FORESTSIDE TOWNHOUSES

Issued for : ISSUED FOR SITE INSTRUCTION # 8

SITE INSTRUCTION # 8

JAP Project No: 19066

Job No: 19066 Sheet No: S-251

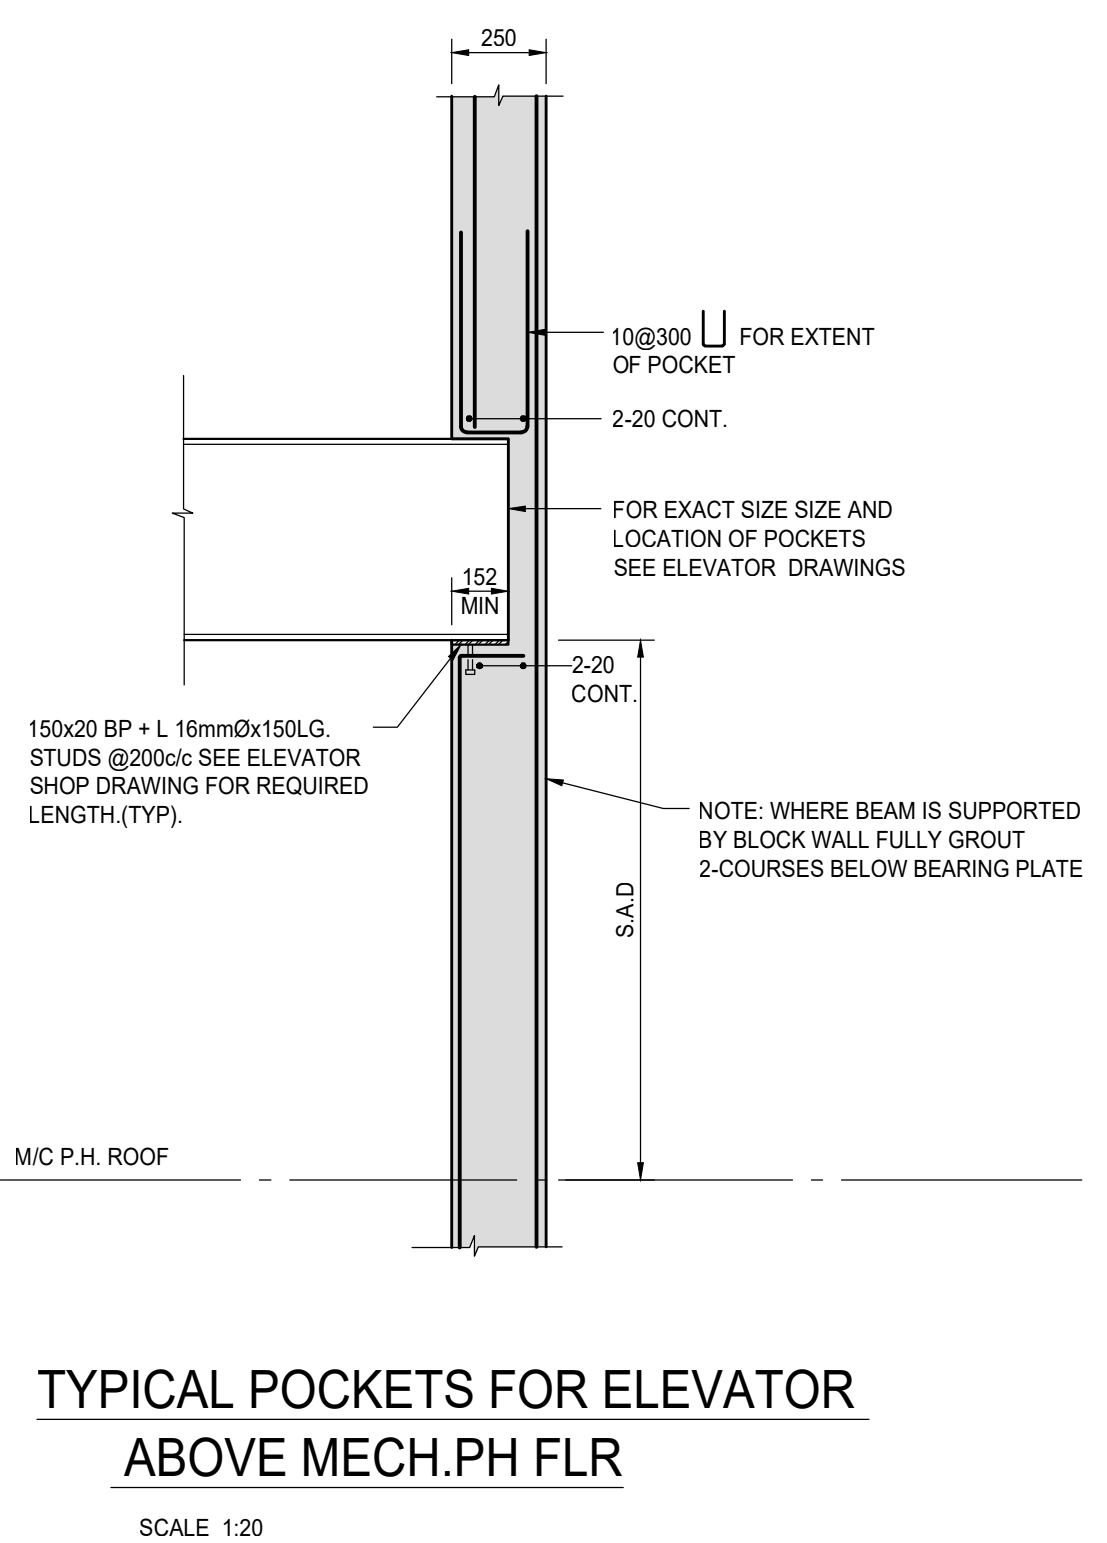
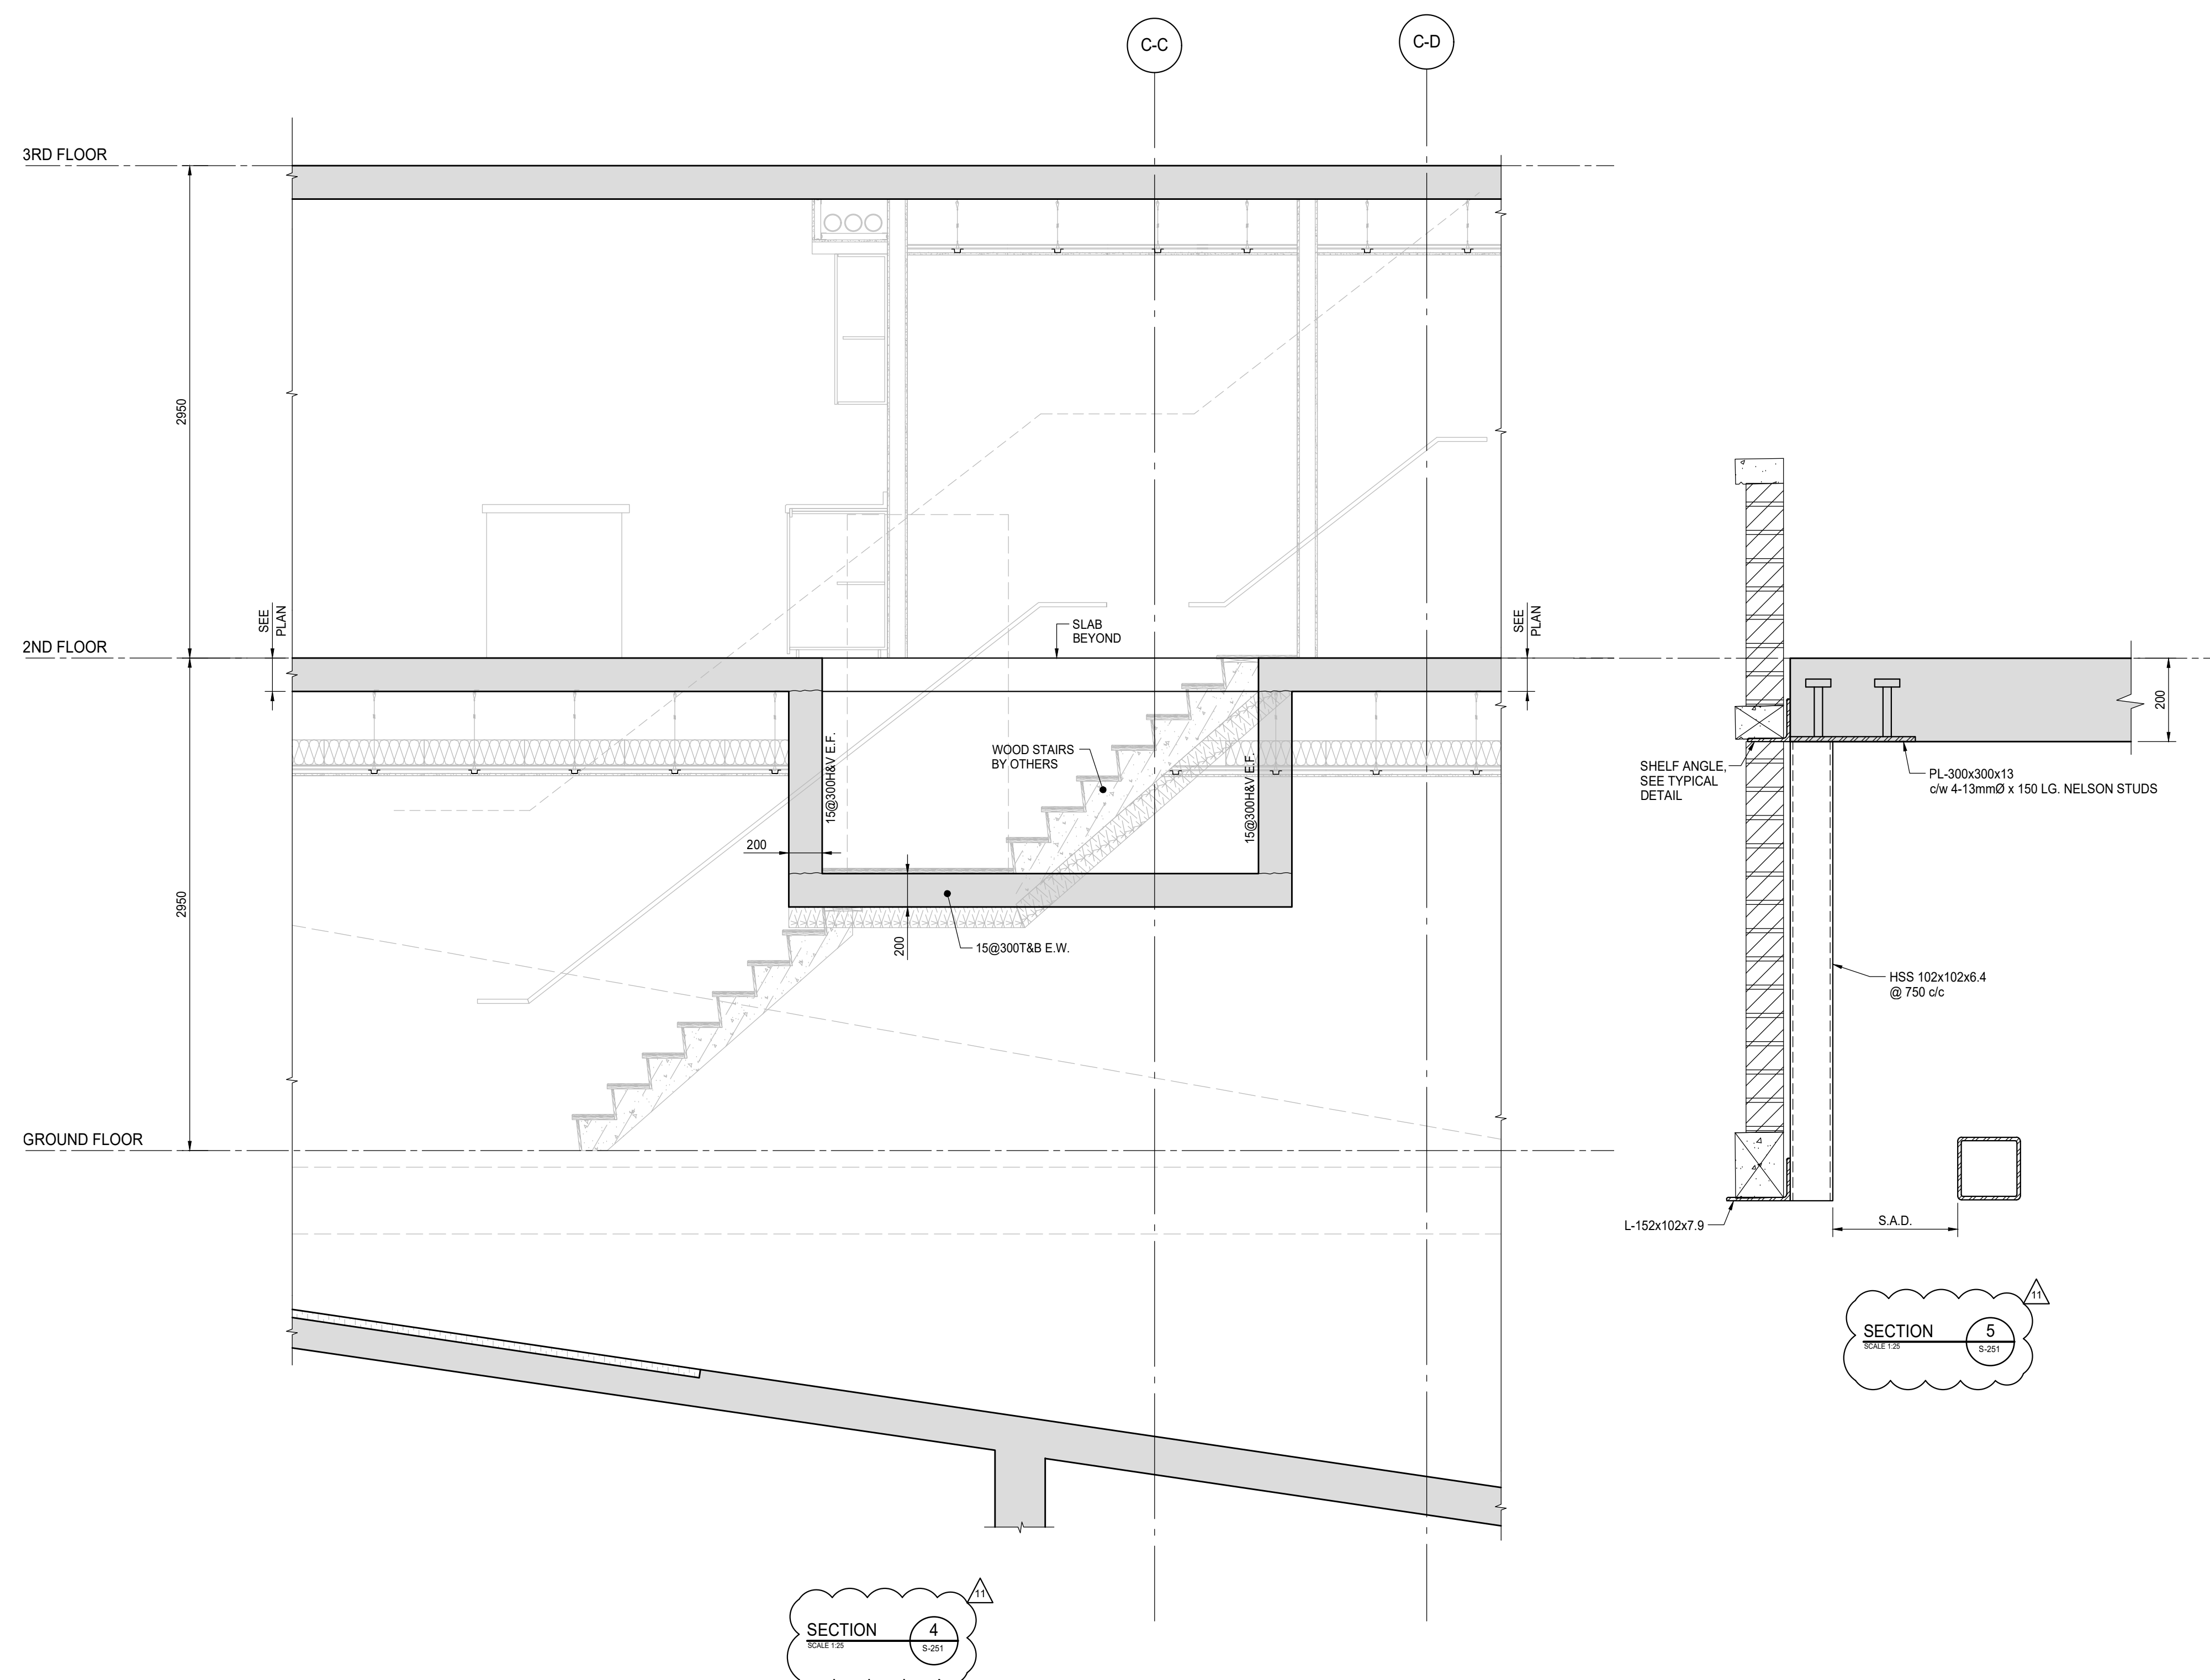
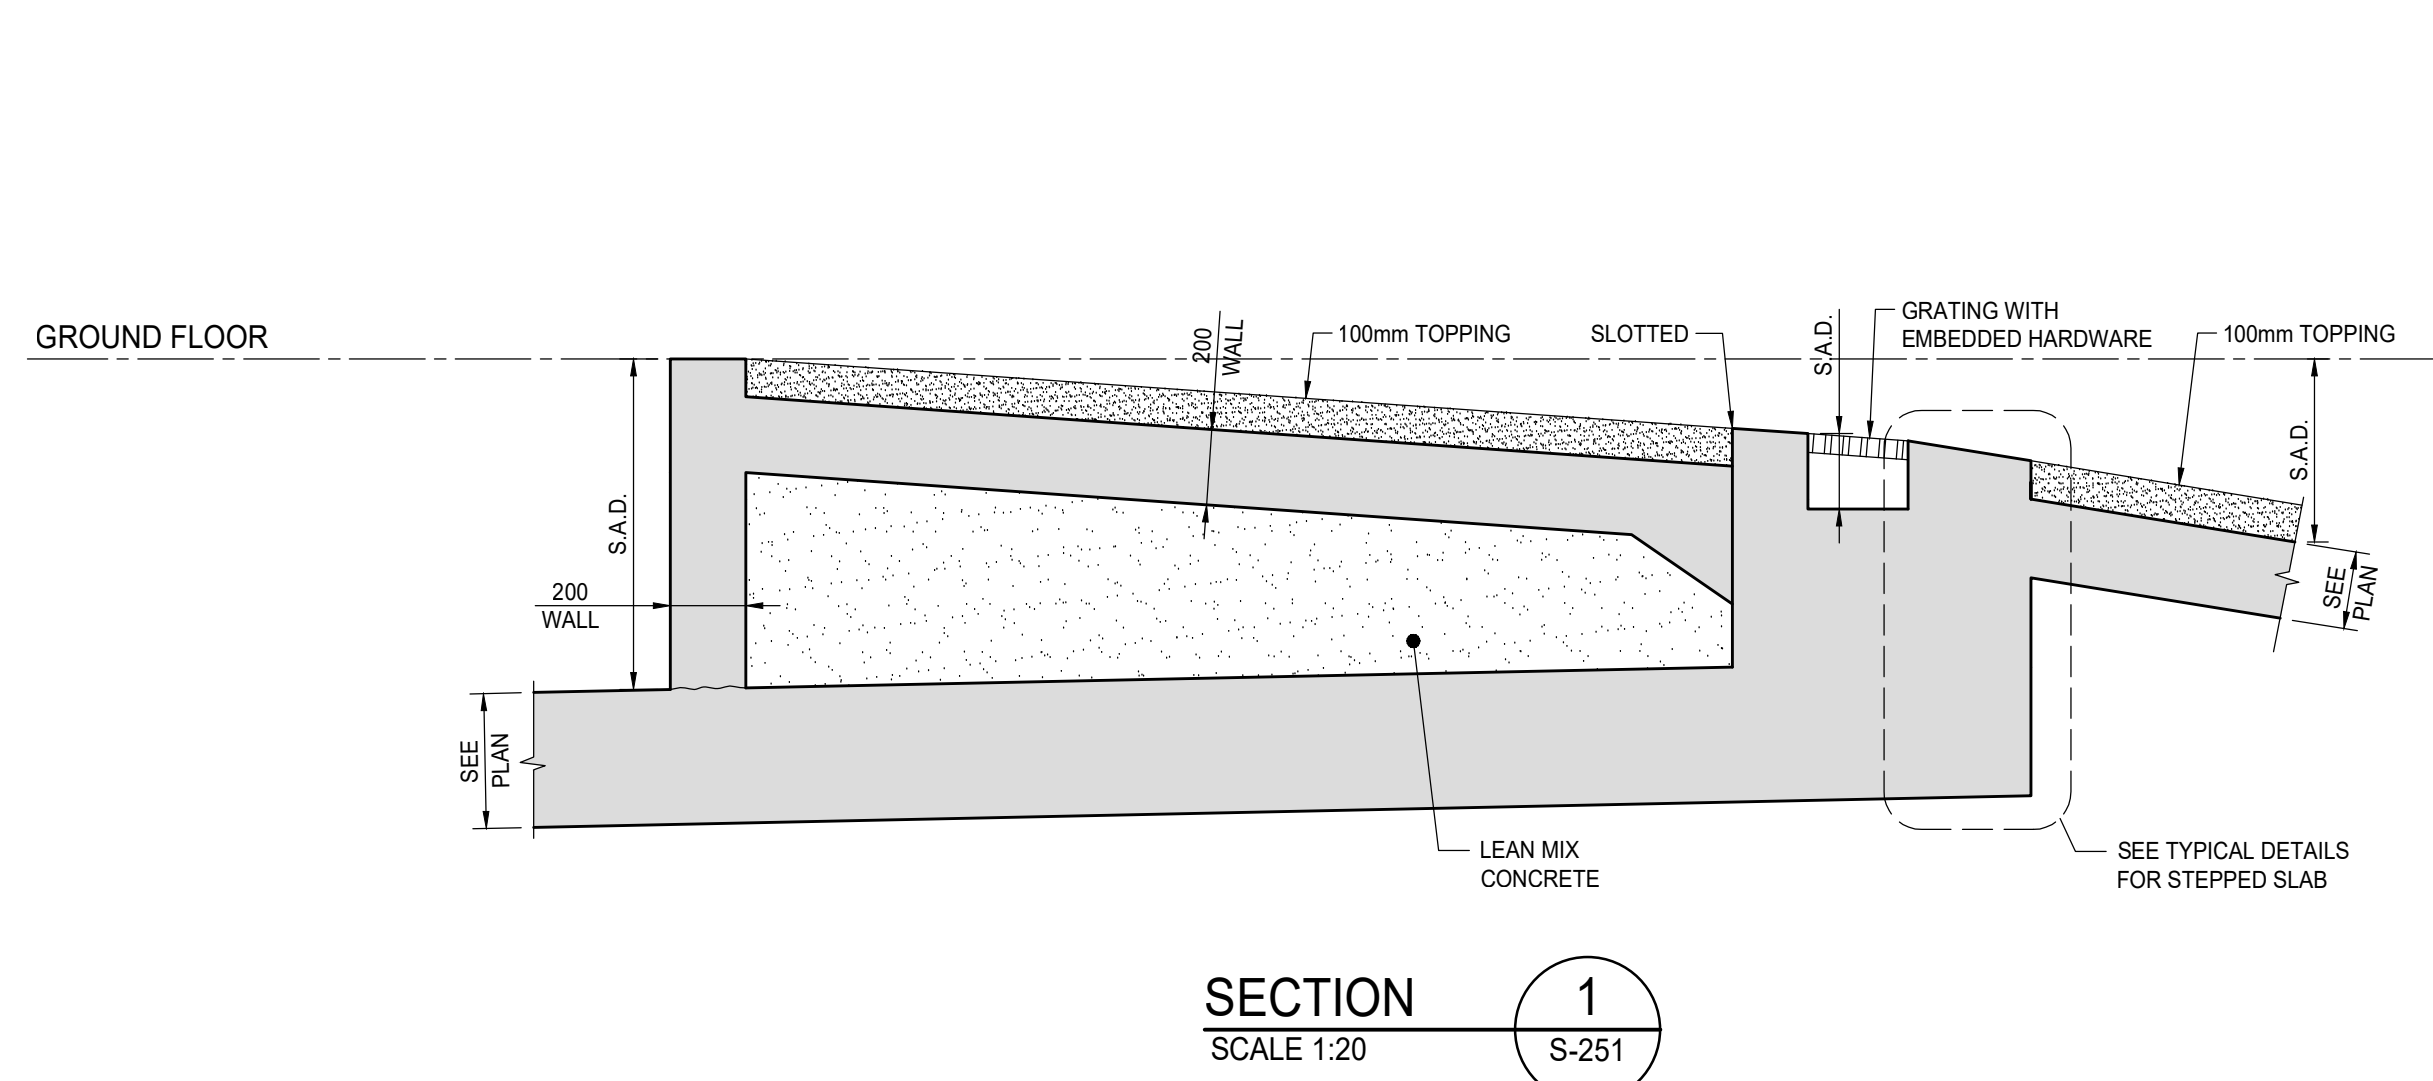
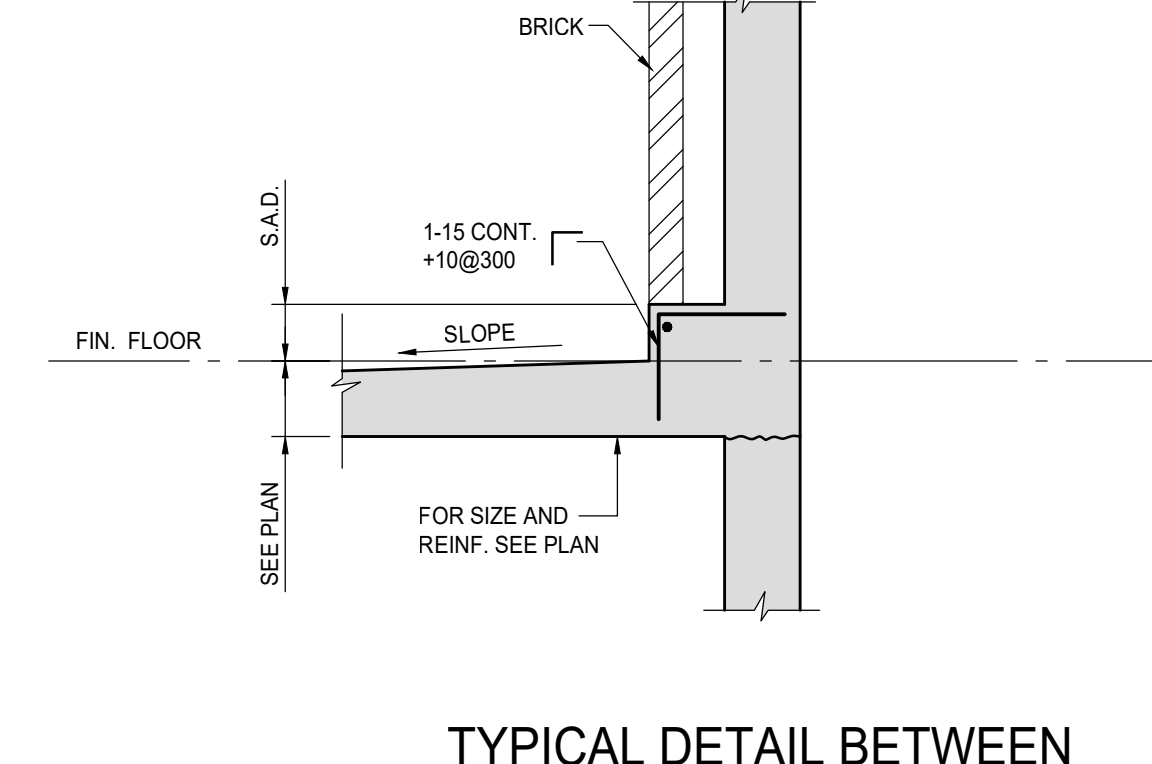
- 1.1 **Refer to Drawing S-102A "GROUND FLOOR FRAMING PLAN"**
 - a) Updated section at slab edge to match as built condition
- 1.2 **Refer to Drawing S-102B "GROUND FLOOR FRAMING PLAN"**
 - b) Updated bubbled area to match slab edge
- 1.3 **Refer to Drawing S-103B "2ND FLOOR FRAMING PLAN"**
 - c) Updated hanging stair box detail and rebar,
 - d) Added section as bubbled
- 1.4 **Refer to Drawing S-201 "SECTIONS"**
 - e) Updated bubbled sections to match as built condition,
- 1.5 **Refer to Drawing S-251 "SECTIONS"**
 - f) Updated bubbled sections
